# IXP1200 Network Processor

## B0 and C0 to D0 Stepping Change Document

*January 2002*

Figure 1. B0 Stepping Package Marking

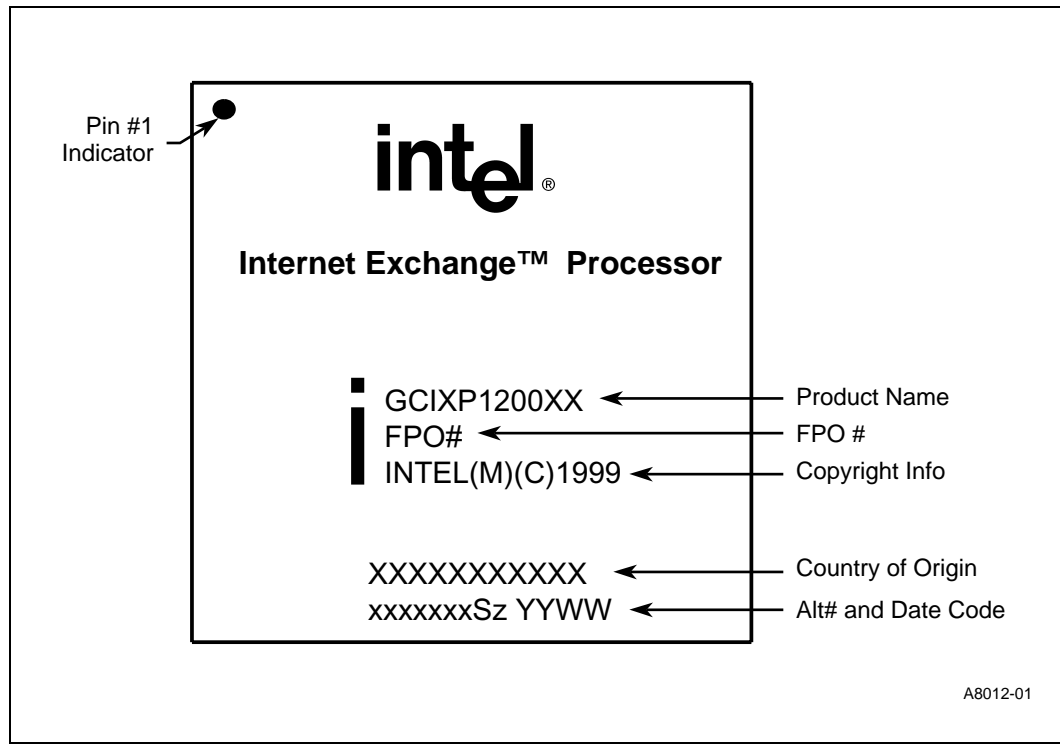
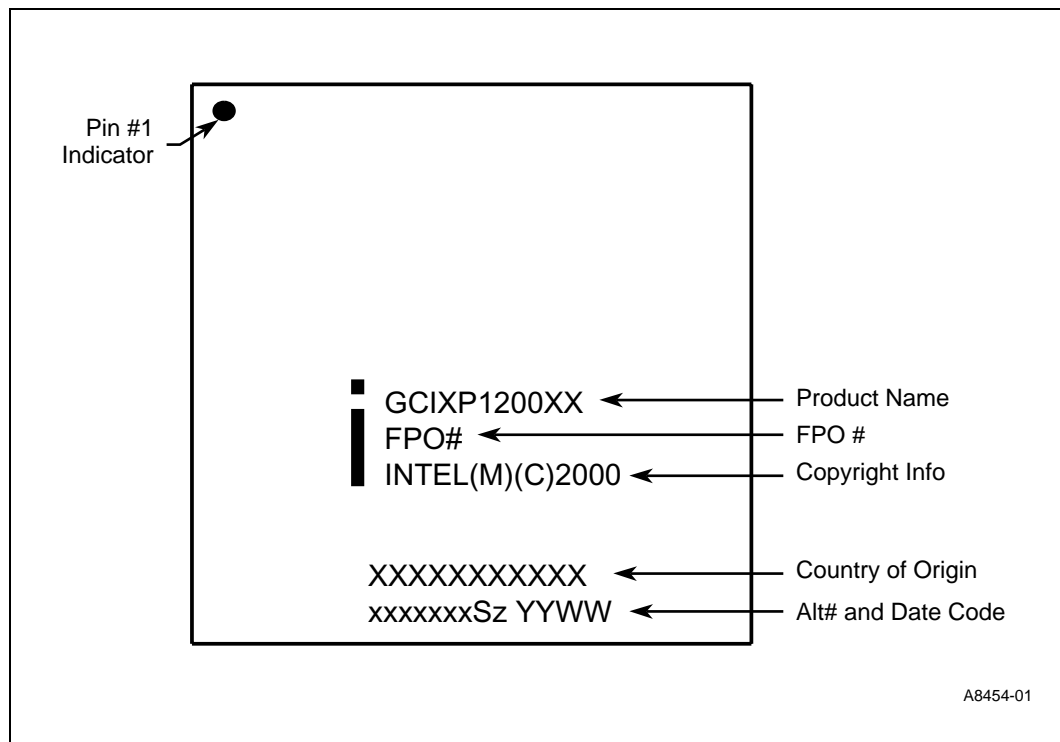
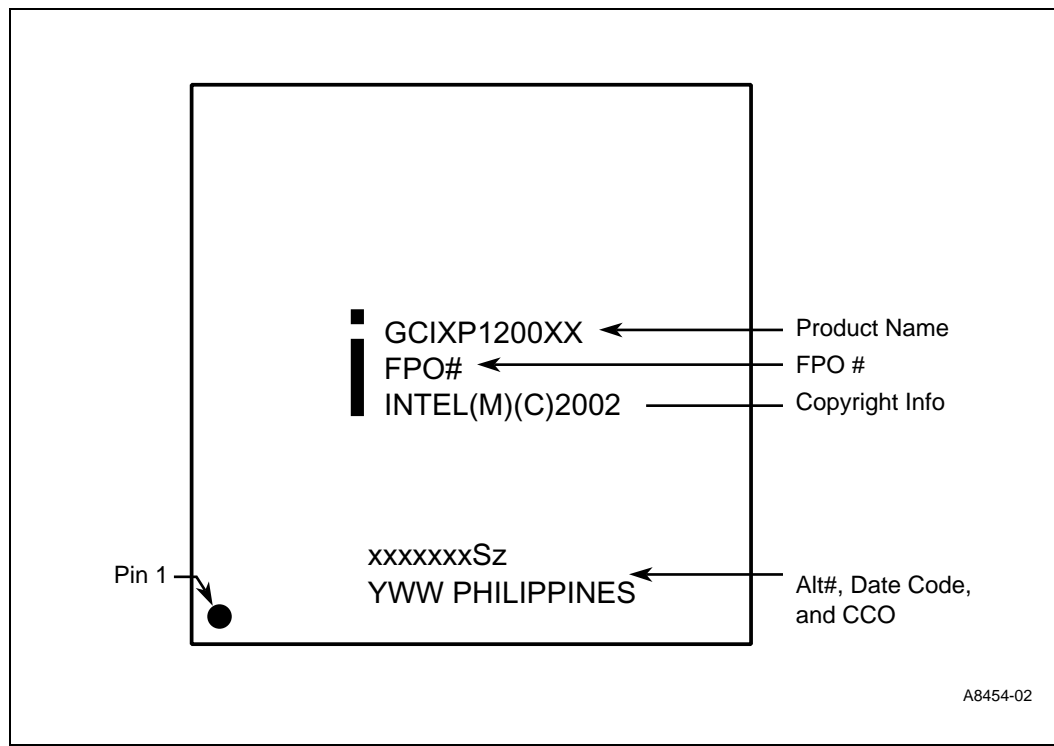
The mark orientation has changed. [Figure 1](#) shows the B0 mark, [Figure 2](#) shows the C0 mark, and [Figure 3](#) shows the D0 mark.
